ORDER UNDER SECTION 96 (2) OF ACT, III OF 1901.

Re: Bungalows on plot No. 15 & 16, C.L.6, Civil
Lines Quarters.

PROPOSED BUNGALOW
ON PLOT NO 15 & 16 SHEET NO C.L. 6
CIVIL LINES QUARTER
SCALE 8 FEET TO AN INCH

AMENDED PLAN FOR PROPOSED DUNGALOW ON PLOT NO 15 & 16 SHEET NO C.L.6

ELEVATION TO WEST SIDE

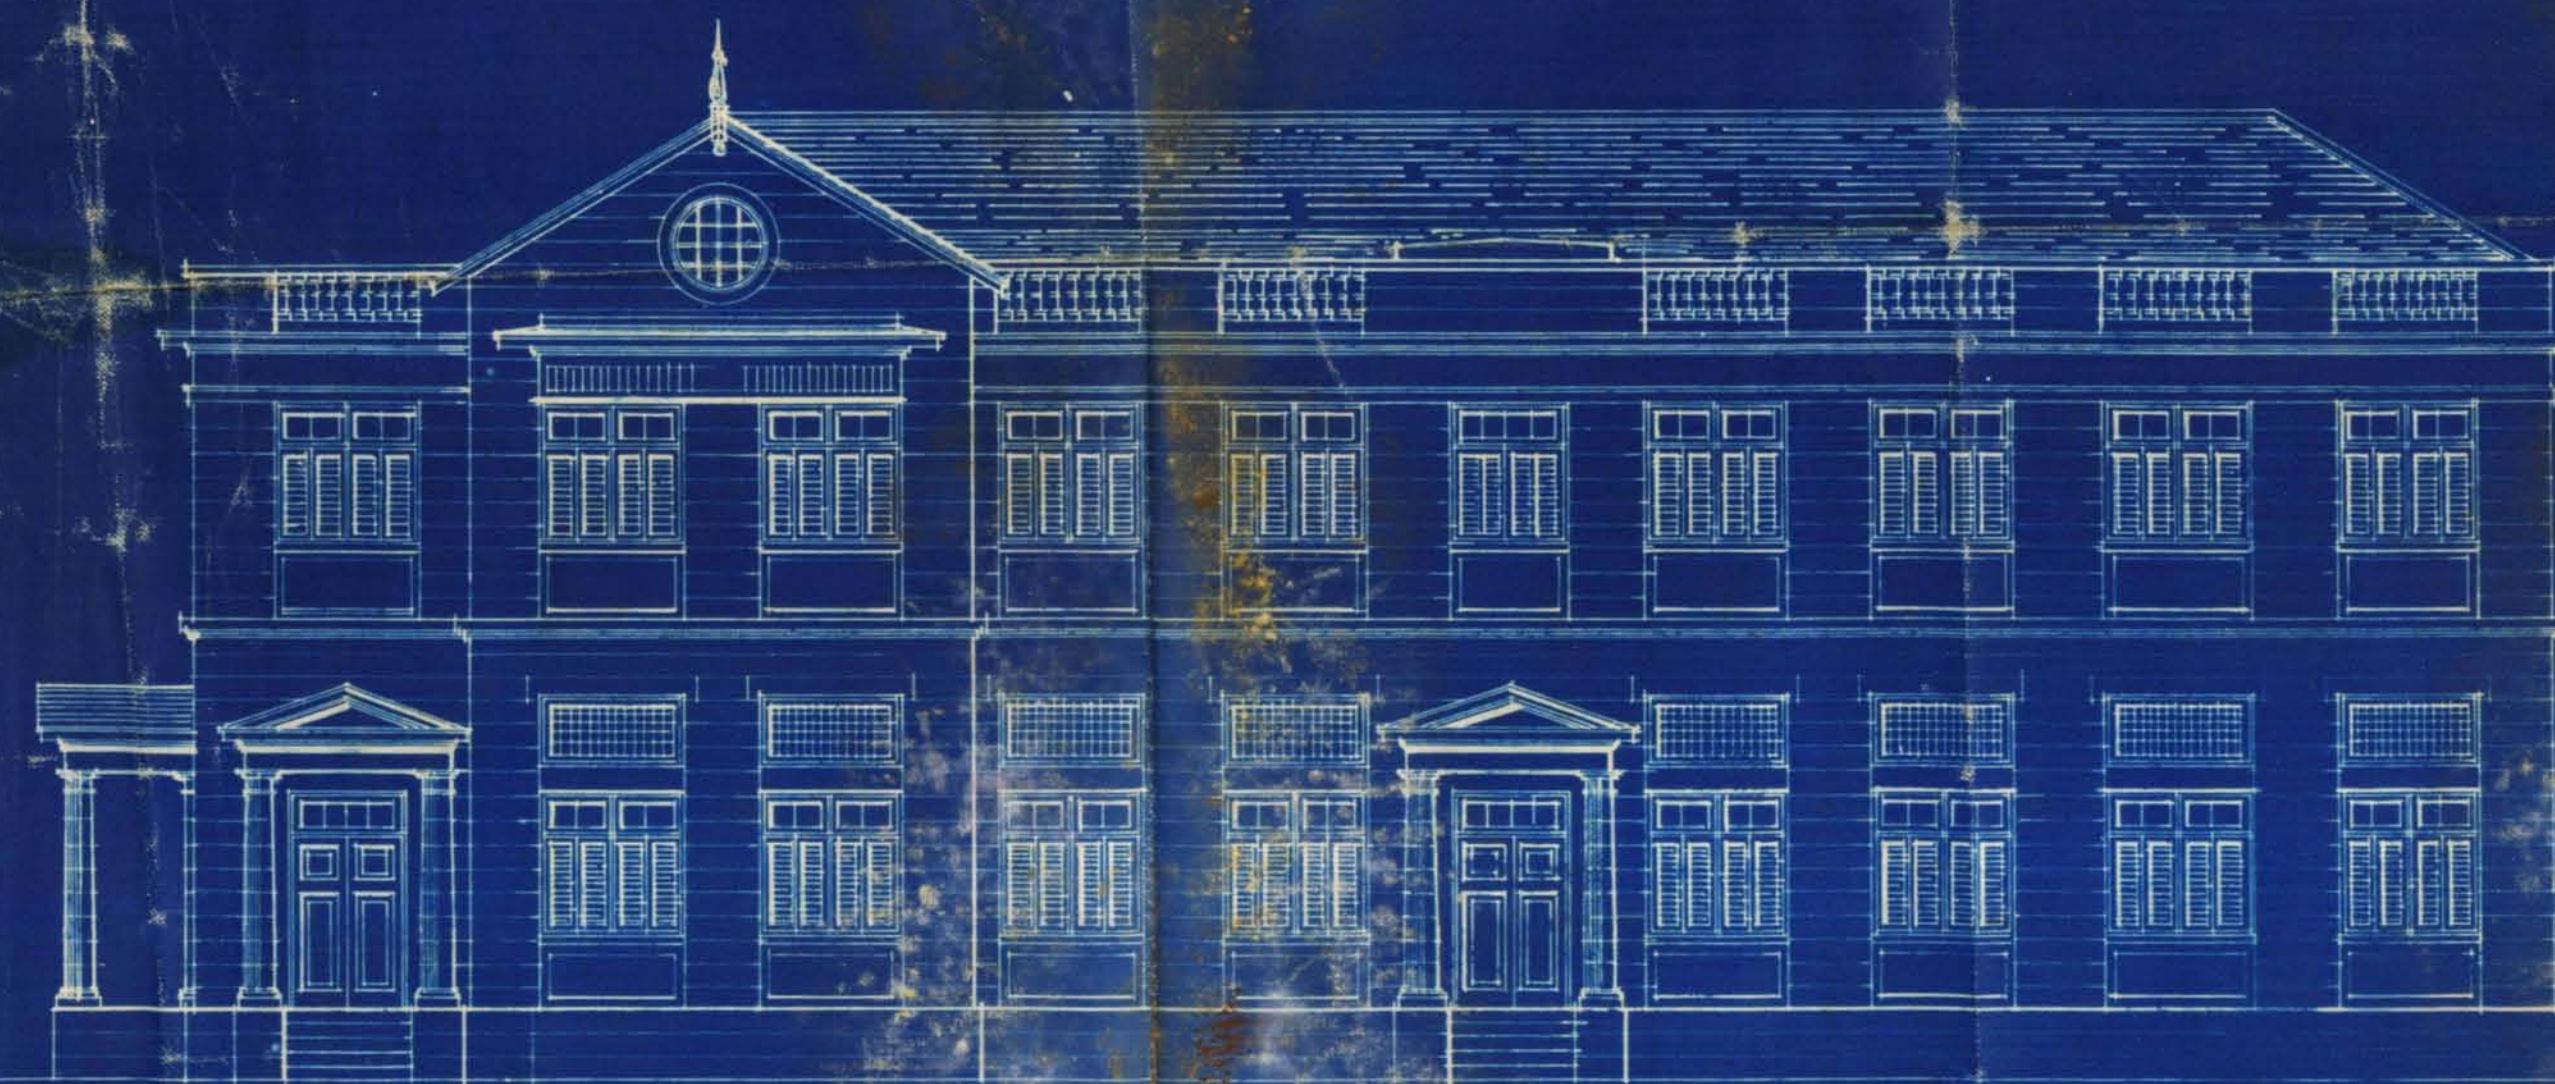
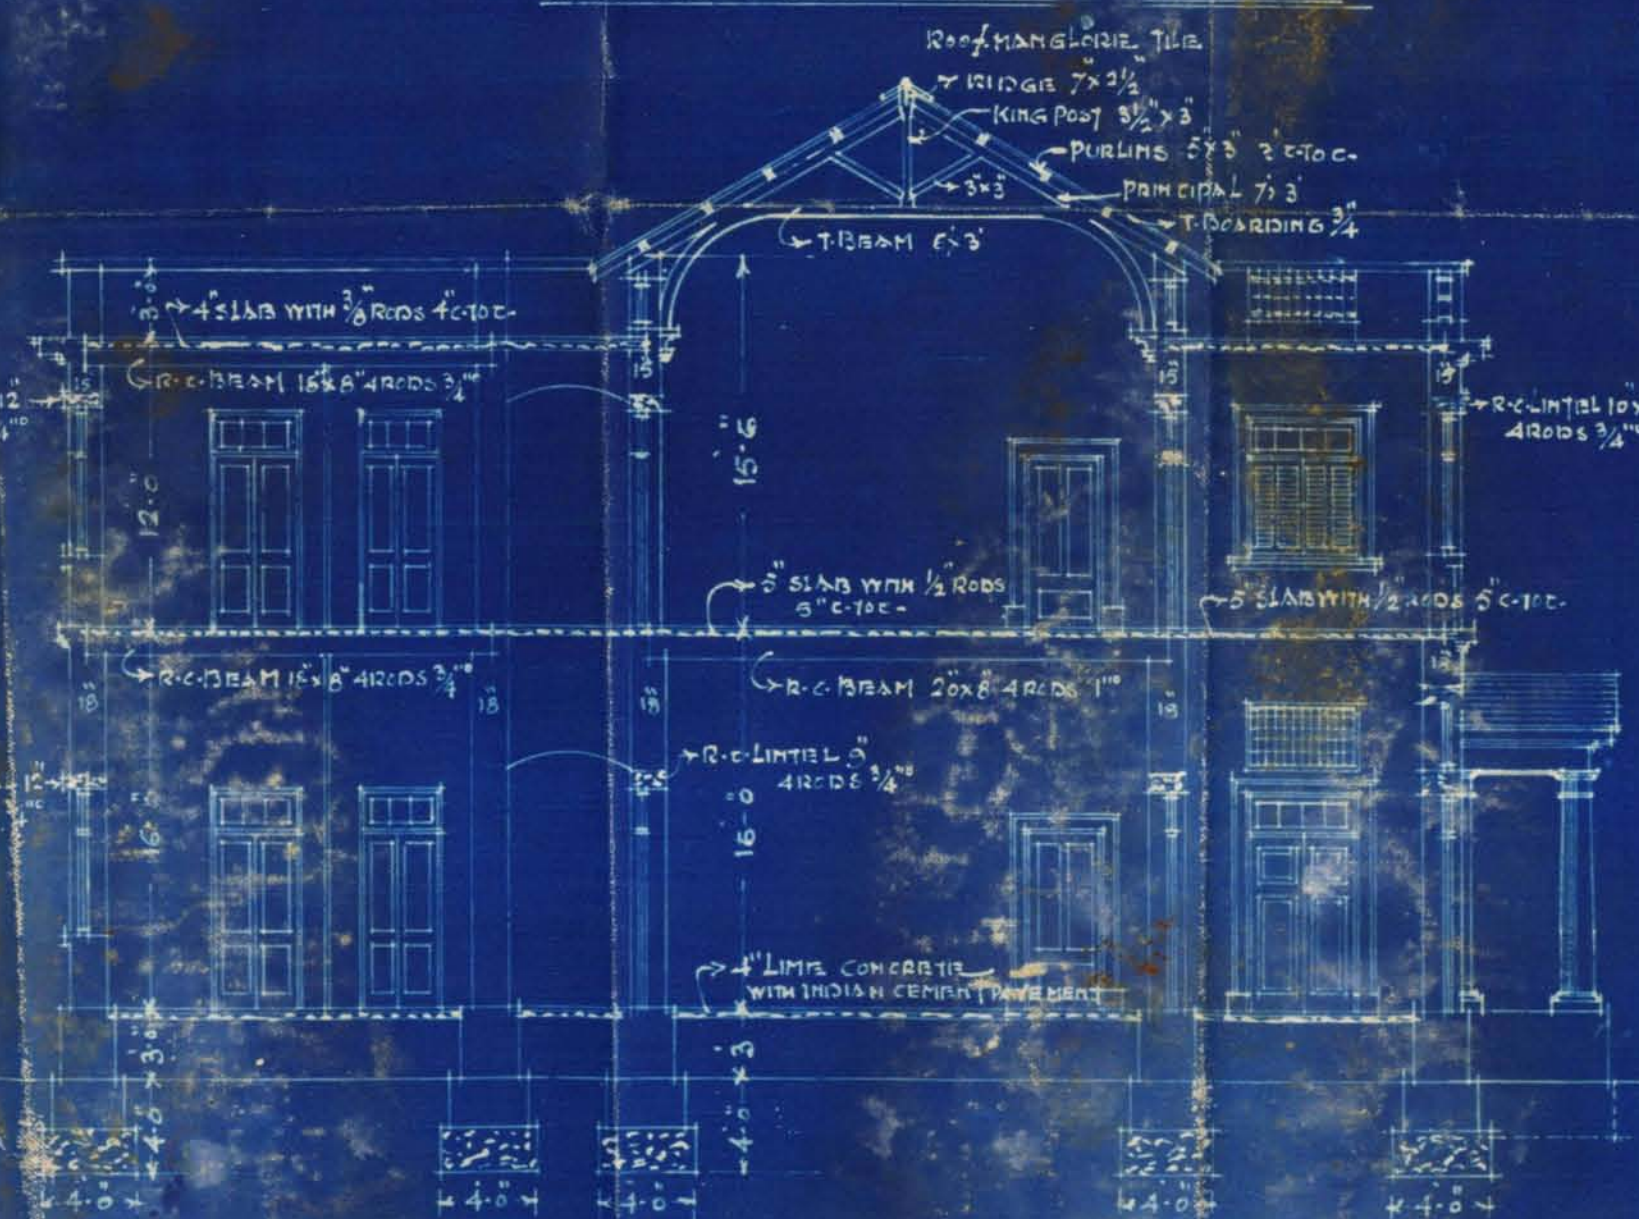
- (1) Title deed must be produced as the plots do not stand in the applicant's name
- (2) measurements of the plots must be written separately
- (3) Calculations of R. C. work are required. 4 rods for 20' span are insufficient
- (4)
- (5)
- (6)
- (7)
- (8)
- (9)

① Title deed must be produced

② Stab of the stair case room should be specified

③ Foundations on plot no. 15 are already lined out on site.

④ Two separate bungalows on separate plots are shown on only one plan.

① Please put up calculation of area, ②
about the deeds and the C.D.C. if necessary
BS ① measuring plots and the
making separate calculation of RB
Work is required for 20' bearing is insufficient

With reference to your memo No. L.M.A. IO233 dated 18th inst, re buildings in plot No/ I5 & I6 C.L.6, we beg to state as under.

(1) The Plots are transfered in the name of our client Mr. Fakirji Cavasji on 27th July 1928, and the Sanads are with the City Deputy Collector.

(2) The measurments of the plots are shewn on the plans.

(3) The beam for 20' span of 20"x8" with 4 rods I" is good enough for 22.3 tons (B.R.C. Fabric hand book table 8) where as ^{The} ~~the~~ actual load will be only 11.2 tons.
